**METROPOLITAN GOVERNMENT OF NASHVILLE AND DAVIDSON COUNTY**

**STAFF RECOMMENDATION**  
**1515 Ashwood Avenue**  
**May 16, 2018**

**Application:** Partial Demolition: New construction - addition  
**District:** Belmont-Hillsboro Neighborhood Conservation Zoning Overlay  
**Council District:** 18  
**Map and Parcel Number:** 10416034900  
**Applicant:** Brittney Mount, Allard Ward Architects  
**Project Lead:** Sean Alexander, sean.alexander@nashville.gov

**Description of Project:** The applicant is proposing to demolish the upperstory of an historic house in order to construct a taller upperstory, and to construct a rear addition. The rear addition will be taller than the historic house.

Figure 2: The roof pitch at 1515 Ashwood Avenue increases as it nears the peak.

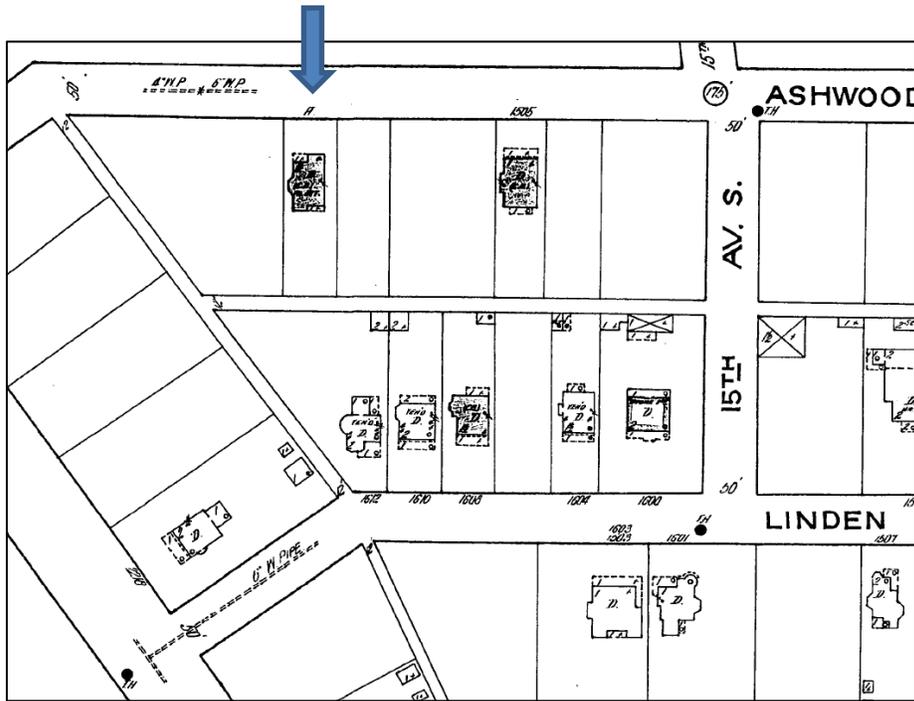
**Demolition:** The roof on the house consists of a side-oriented gable with three gabled dormers on the front slope and a shed dormer on the rear. The three front dormers have a pitch of approximately 12:12. The primary gable has a 3½: 12 pitch at the eaves, increasing to 5½:12 as it nears the peak. The applicant proposes to remove the upperstory entirely and construct a new one with only a 5½:12 pitch on the primary roof and a pair of gabled dormers with an 8:12 pitch.

The roof of any building, regardless of whether it is high style or of a vernacular design, is an integral component of its architectural and historical integrity, and removing it would be severely detrimental to the building's status as contributing to the character of its neighborhood. At this time there is no evidence to suggest that the existing roof form is not original. That the original form has architectural significance is clear, particularly when the unusual roof shape and high visibility is taken into account. Staff finds that the demolition of the existing upperstory is an inappropriate demolition under section III.B.1.a of the design guidelines for the Belmont-Hillsboro Neighborhood Conservation Zoning Overlay.

Site Plan

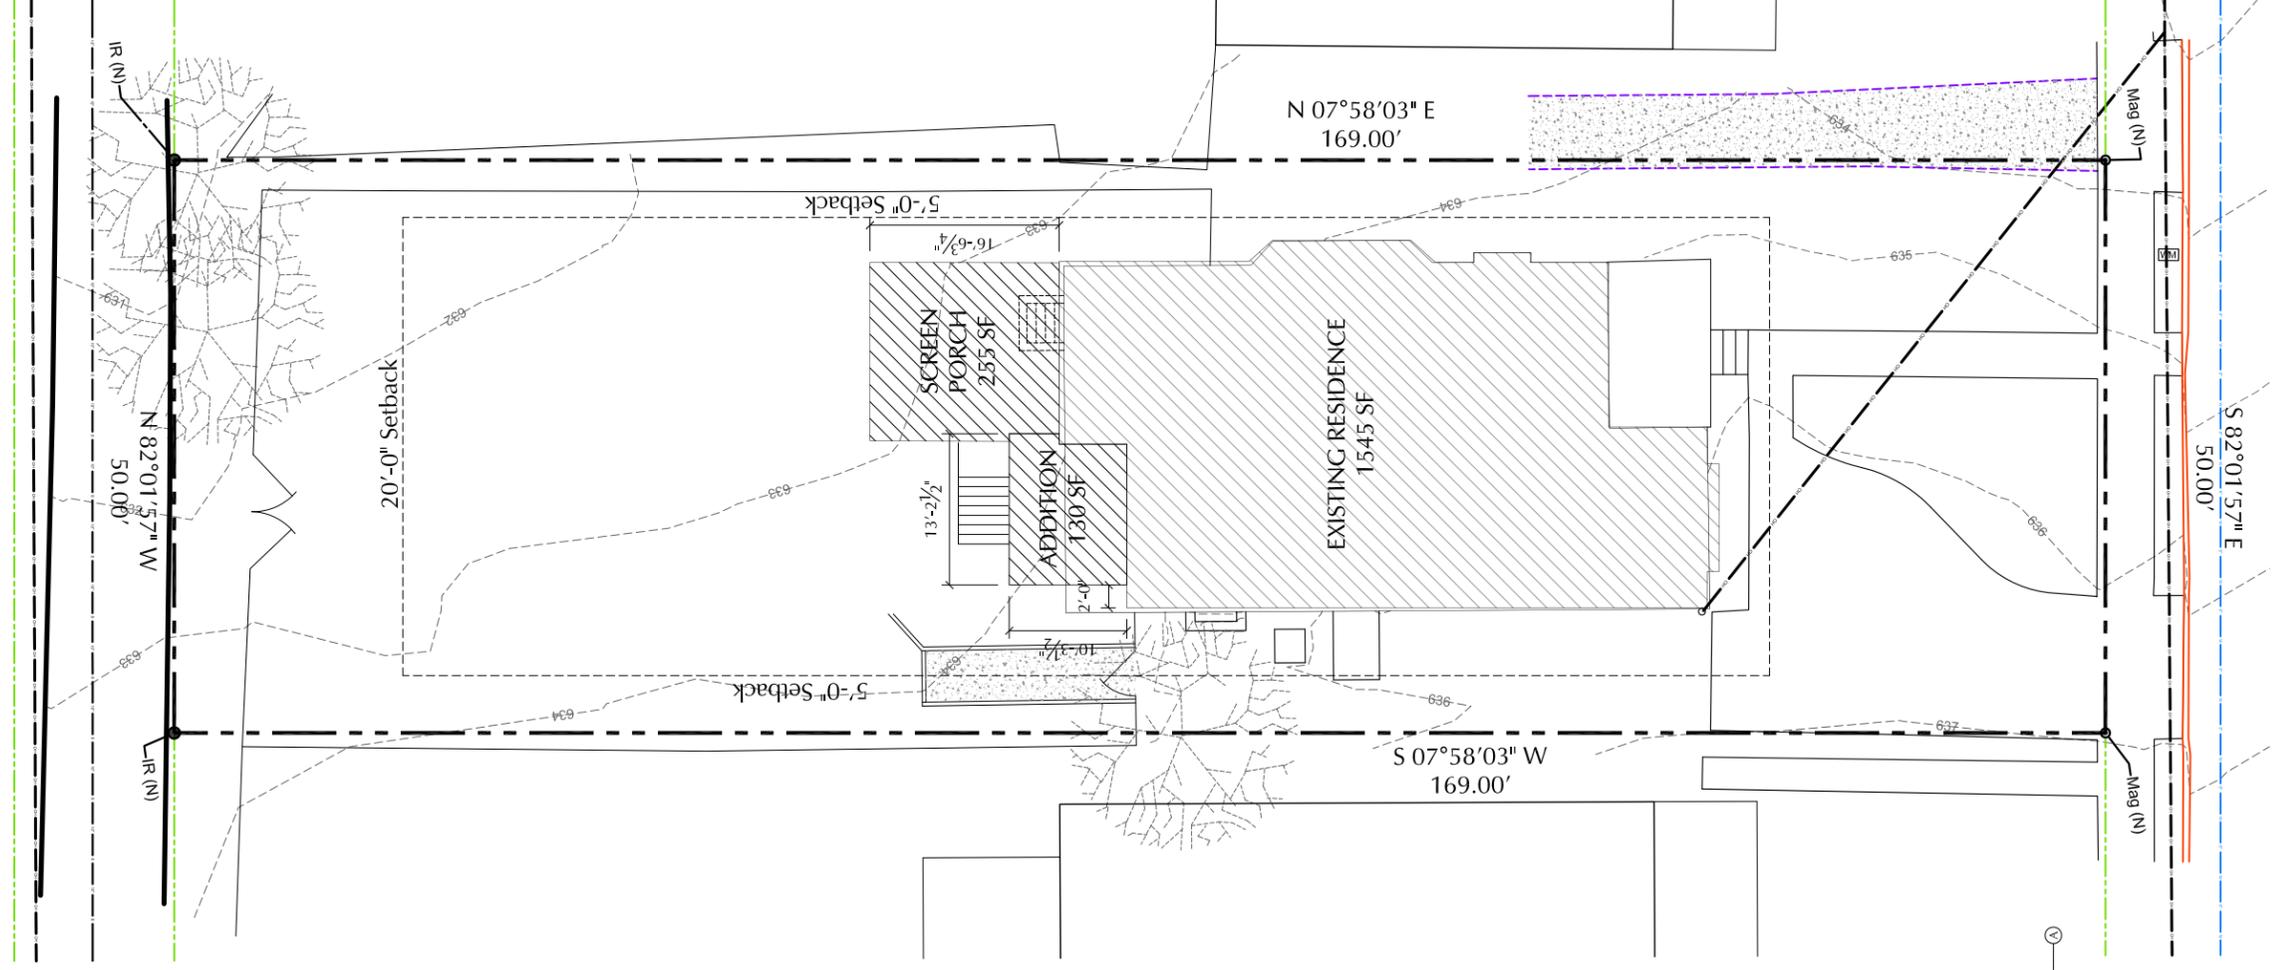
The proposed rear addition would be stepped in from the sides of the house by two feet (2') on both sides, measured from the wall of the upperstory gable field. This is an appropriate location for a rear addition and would meet section II.B.2.a and II.B.2.e of the

The footprint of the rear addition would extend twenty-two feet (22') to the rear and would be stepped in from the walls of the house by two feet (2') on each side, having roughly the same footprint as the existing rear screened porch. An addition with this footprint would be appropriate and if the addition were not taller than the historic house and did not require the demolition of the upperstory. Such an addition can often be approved administratively.

Setback & Rhythm of Spacing: The footprint of the house would not be significantly altered by the partial demolition and addition, and therefore it will not affect the setbacks and rhythm of spacing. Staff finds that the project would meet Section II.B.1.c of the design guidelines.

Drawings:  
Demolition Plans

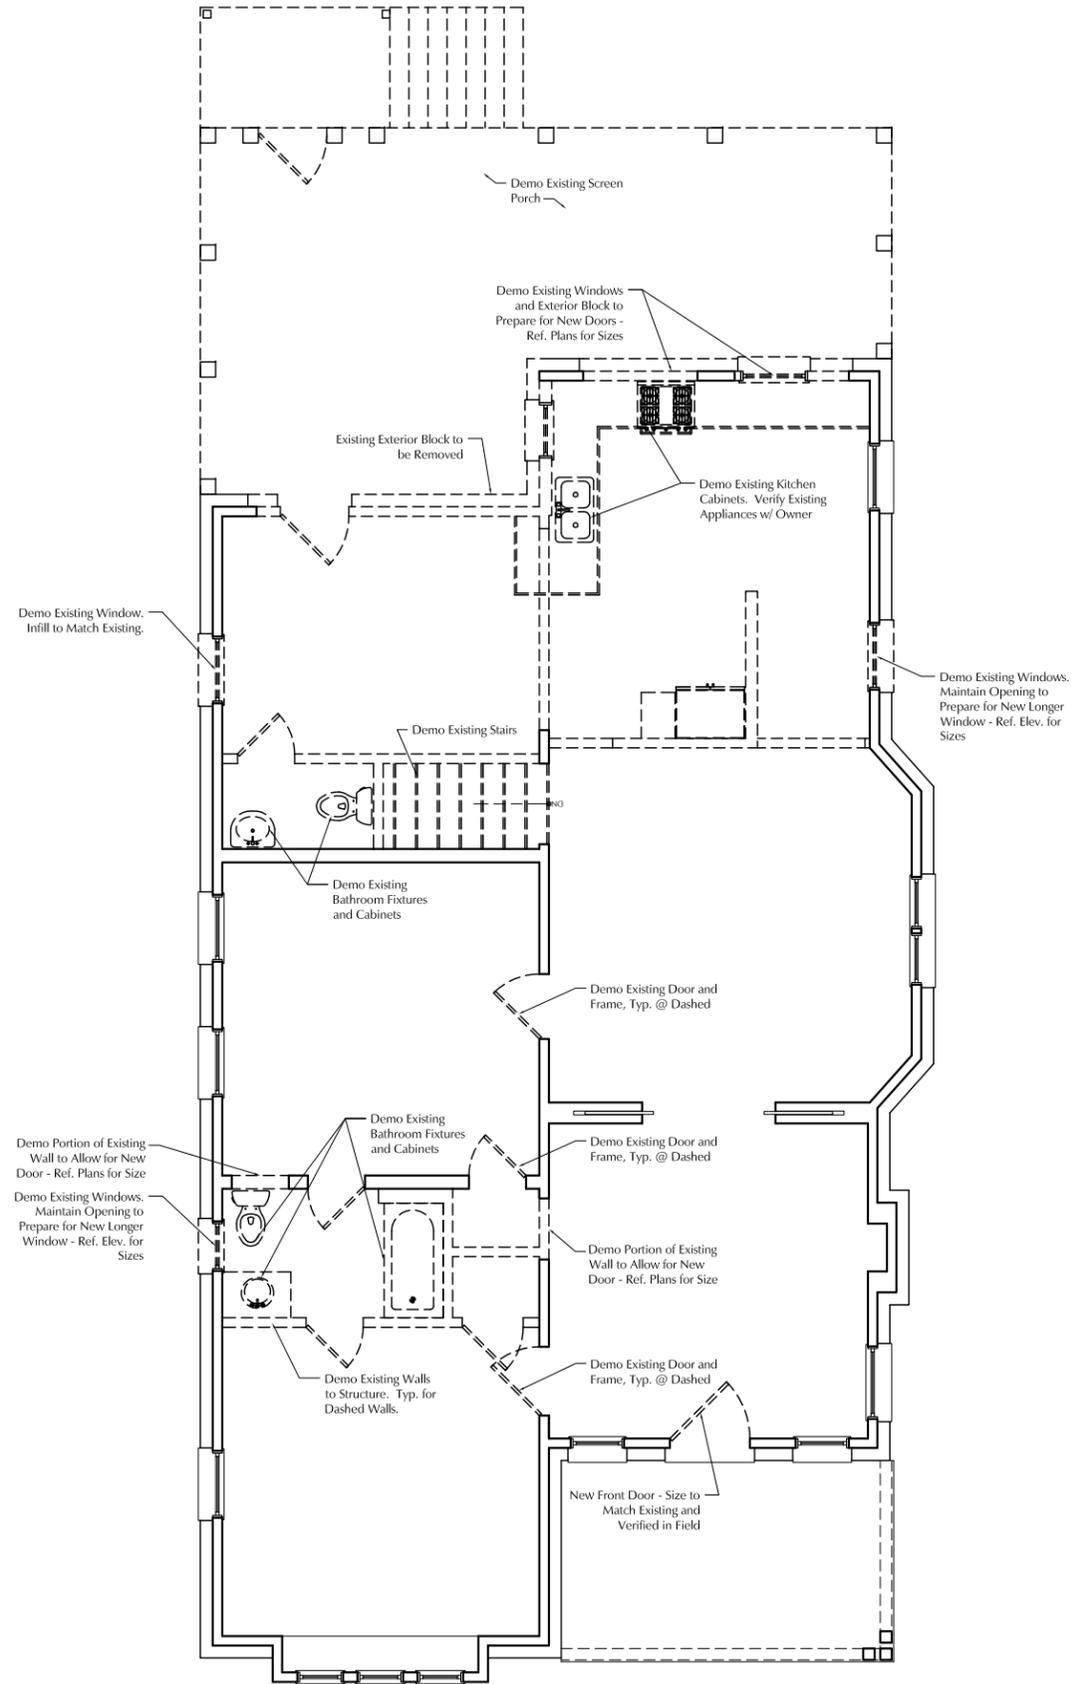
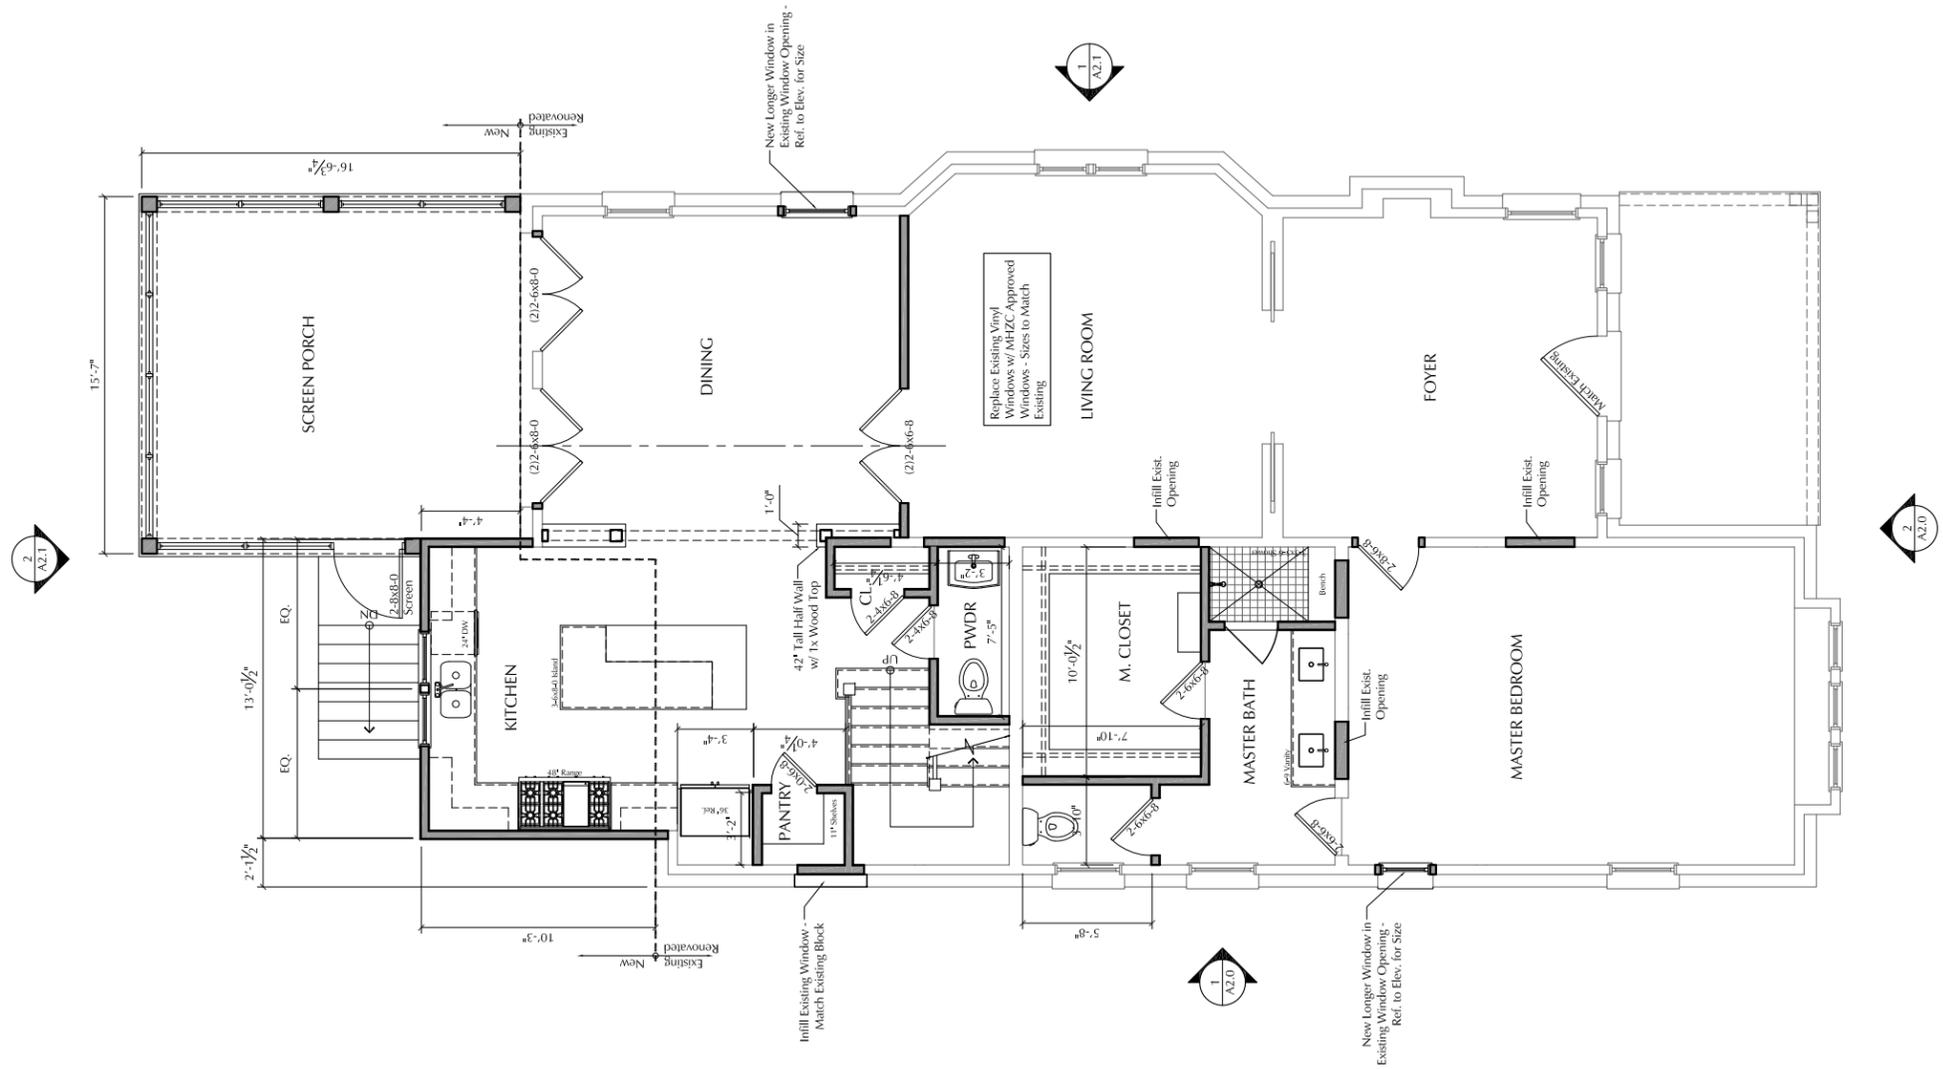
In demolishing the upperstory and constructing a new upperstory, the window patterns in the gable fields and the dormer configuration would also be altered. The appropriateness of altering the window pattern could be appropriate, but it cannot be considered independent of the larger scope of demolition. The proposal also shows the sizes of an existing first story window opening on both the left and right sides being increased in height, and one window on the left side being filled in. Alteration of the historic window pattern is considered partial demolition. The number of proposed window alterations combined with the change in roof form, does not meet section III.B.1 of the design guidelines.

A rear screened porch would also be demolished. This porch is not historic, and does not contribute to character of the building, and its demolition is appropriate under section III.B.1.a of the design guidelines.
